Comment Response Document
Regarding the Total Maximum Daily Load of Polychlorinated Biphenyls in South River
Mesohaline Chesapeake Bay Segment, Anne Arundel County, Maryland

The Maryland Department of the Environment (MDE) has conducted a public review of the proposed Total Maximum Daily Load (TMDL) of Polychlorinated Biphenyls (PCBs) in the South River Watershed. The public comment period was open from July 17, 2014 through August 15, 2014. MDE received three sets of written comments from the South River Federation (Capt. Diana Muller, et.al.), Mr. Christopher Phipps, P.E. of Anne Arundel County, Dept. of Public Works, and a number of very similar letters and comments from Ms. Gwenn Azama, Ms. Kincey Potter, Ms. Beverly Marcus and Mr. John Koontz.

Figure 1: MDE tPCB and Stations in South River, MD (Provided by Commentors)

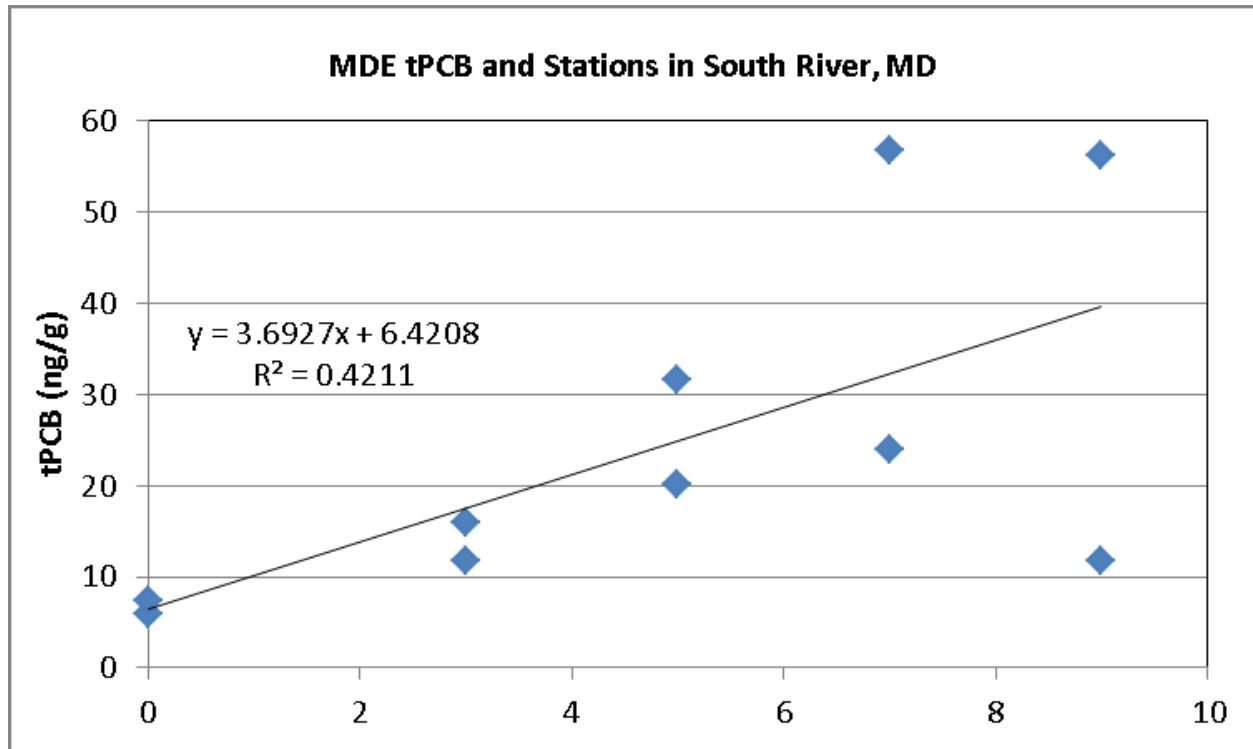
The Commentor asserts that the tPCB water column data shows that the tPCB concentrations are higher in the South River than in the Chesapeake Bay mainstem. “...The Chesapeake Bay mainstem tidal influence and resuspension and diffusion from the bottom sediments are the two primary sources of tPCB baseline loads resulting in the PCB impairment in the South River embayment. MDE’s own sediment tPCB data shows an increase with tPCB concentration as going from Bay into River- meaning the concentrations at Stations STH5 are higher than the Chesapeake Bay ($r^2= 0.42$)- stations are plotted over distance (See Figure 1). This is consistent with the Muller and Muller, 2014 paper where results show that it is the South River polluting the Bay and not the Bay polluting the South River. Either the data was entered into the MDE model incorrectly or they completely study was flawed. MDE’s own data is counter to what they are stating in their comments.

The figure provided in Comment 6, shows PCB concentrations in the bottom sediments of the South River. Because of the complexity of environmental processes involved in the transport and deposition of PCBs sorbed to sediment in tidal waters, it is difficult to use these spatial trends to draw any reliable conclusion about the current sources of PCBs to the embayment.
